Subject: Submission of Supplemental Information to Amend the U.S. Nuclear Regulatory Commission Certificate of Compliance No. 1031 for the NAC International MAGNASTOR[®] Cask System

Docket No. 72-1031

NAC International (NAC) hereby wishes to supplement Reference 4. This supplement consists of two replacement pages (see Attachment 1) for Appendix A to Reference 1, Technical Specifications and Design Features for the MAGNASTOR System. The specific changes being requested are:

Additional Text Incorporated into the
MAGNASTOR FSAR via
10 CFR 72.48 Determination
(Nonproprietary Version)

Figure 6.7.1-2 PWR Basket Structure

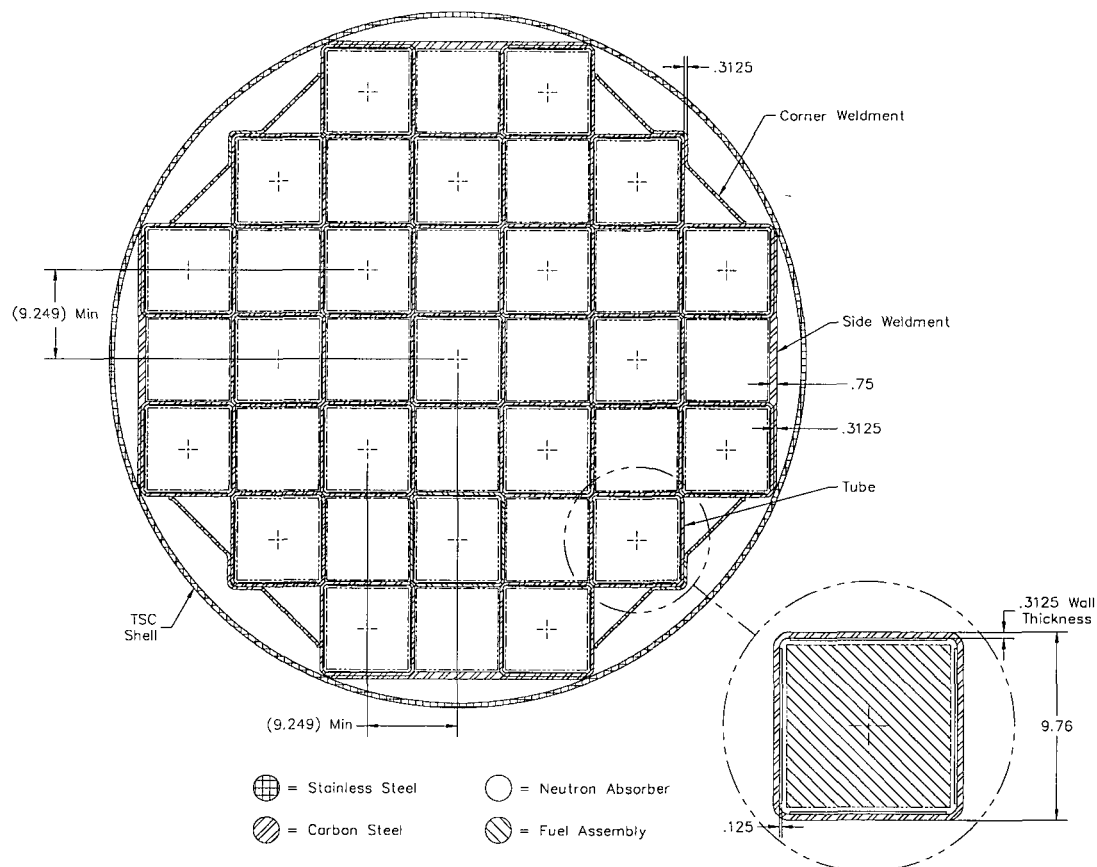
1. Dimensions in inches.
2. Assembly fuel pin array is explicitly modeled. Shown as homogenized area for illustration purposes only.
3. *Represents square tube basket aligned at 45° with 13.08-inch minimum interface (diagonal flat-to-flat) width.*

- b) Acceptance and qualification testing of borated aluminum alloy and borated MMC neutron absorber material shall be in accordance with Sections 10.1.6.4.5, 10.1.6.4.6 and 10.1.6.4.7. Acceptance testing of Boral shall be in accordance with Section 10.1.6.4.8. These sections of the FSAR are hereby incorporated into the MAGNASTOR CoC.
- c) Soluble boron concentration in the PWR fuel pool and water in the TSC shall be in accordance with LCO 3.2.1, with a minimum water temperature 5-10°F higher than the minimum needed to ensure solubility.
- d) Minimum fuel tube outer diagonal dimension
- PWR basket — 13.08 inches
- BWR basket — 8.72 inches

Figure 6.7.4-2 BWR Basket Structure

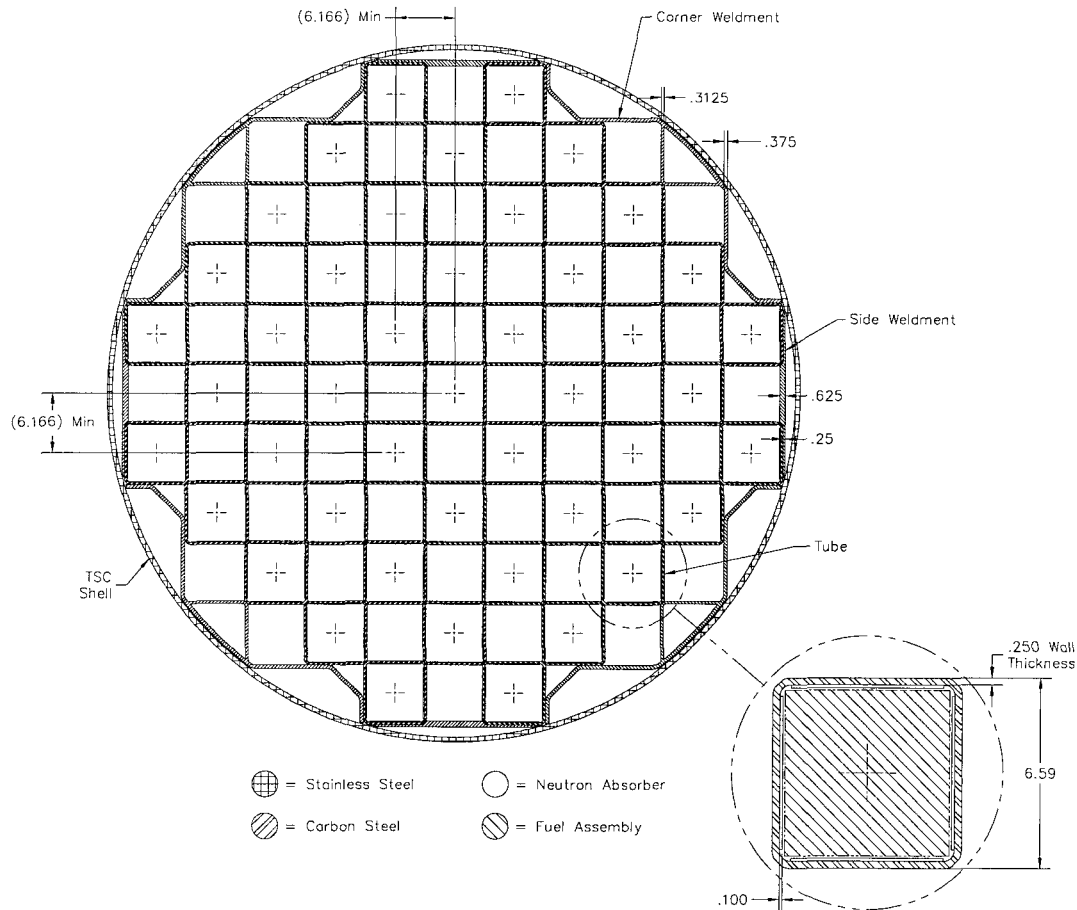
1. Dimensions in inches.
2. Assembly fuel pin array is explicitly modeled. Shown as homogenized area for illustration purposes only.
3. *Represents square tube basket aligned at 45° with 8.72-inch minimum interface (diagonal flat-to-flat) width.*
